STINSON DIVISION

TITLE: Tail Wheel Installation

BULLETIN NO. 252

MODELS AFFECTED: 108 (Voyager and Flying Station Wagon)

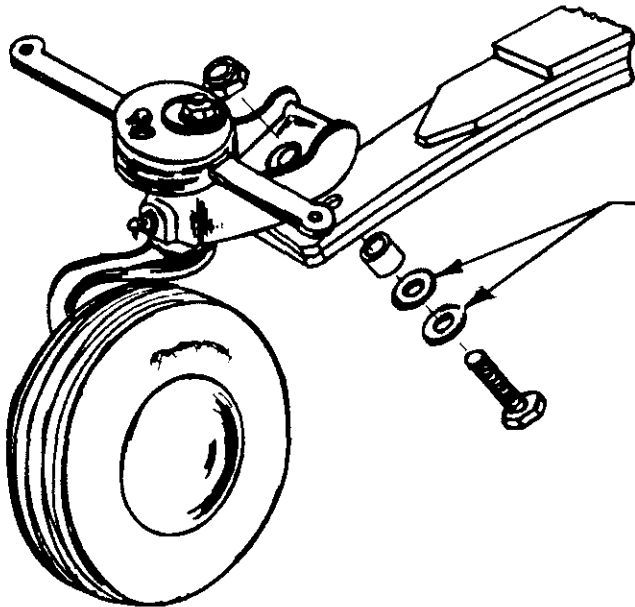
We recently received several reports on the subject of non-functioning steerable tail wheels. A complete investigation of this subject indicated that the tail wheel steering arms were of proper specifications and that the difficulty, where encountered, was caused by the tail wheel arm striking the end of the tail wheel installation bolt. When the tail wheel steering arm swings forward it strikes the end of the bolt and jams the tail wheel mechanism before it reaches the release point.

If any Voyagers in your territory are reported to be experiencing this type of difficulty, we recommend that the tail wheel assembly bolt be removed and two washers installed under the head of the bolt as indicated in the sketch below.
